Access Compliance Report

Public Rights-of-Way

Intersection ID: 18787	Main Street: MONROE_RD	Cross Street: WOODBERRY_RD	Location: SW
ADA ID: 76E84C7F2BCD	Ramp Type: PerpDiag	Initial Pass/Fail: Fail	Overall Compliance: No
		Severity Score: 12.5

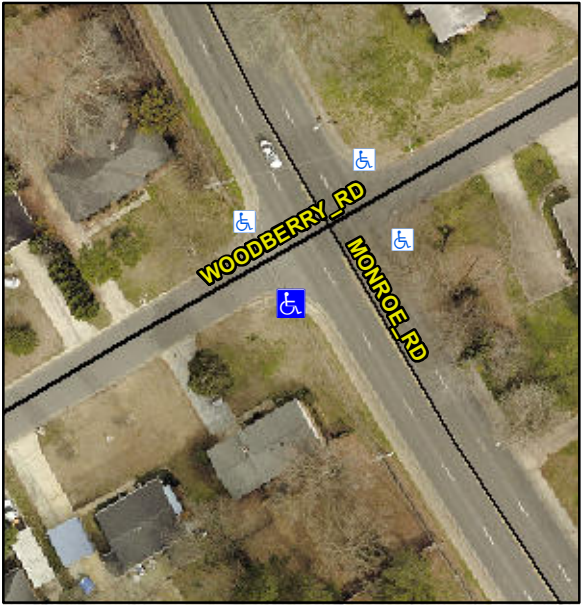
Codes/Mitigation Info/Possible Solution			Field Measurements/Component Compliance			
	Possible Solutions:		Compliance	Description	Data	
	Remove & Replace Curb Ramp With Two New Directional Ramps or Equivalent.		No	Ramp Length (in)	60.0	Ramp Slope (%)
			Yes	Ramp Width (in)	48.0	Ramp XSlope (%)
			N/A	Flare Type LT	N/A	Flare Type RT
			N/A	Flare Slope LT (%)	N/A	Flare Slope RT (%)
			N/A	Flare Traversable LT?	N/A	Flare Traversable RT?
			N/A	Landing Length (in)	N/A	DWS Provided?
			N/A	Landing Width (in)	N/A	DWS Contrast?
			N/A	Landing Slope (%)	N/A	DWS Length (in)
			N/A	Landing X Slope (%)	N/A	DWS Full Width?
			N/A	Landing Curb? (Y/N)	N/A	DWS Offset (in)
			N/A	Shared Landing?	N/A	
			N/A	Gutter Ponding?	N/A	Gutter Slope (%)
			N/A	Gutter Lip Ht (in)	N/A	Gutter X Slope (%)
			N/A	Painted X Walk1?	No	Painted X Walk2?
				X Walk 1 Direction	To E	X Walk 2 Direction
			N/A	X Walk 1 Width (in)	N/A	X Walk 2 Width (in)

Not Found, R304.2.2

Remove & Replace Curb Ramp With Two New Directional Ramps or Equivalent.
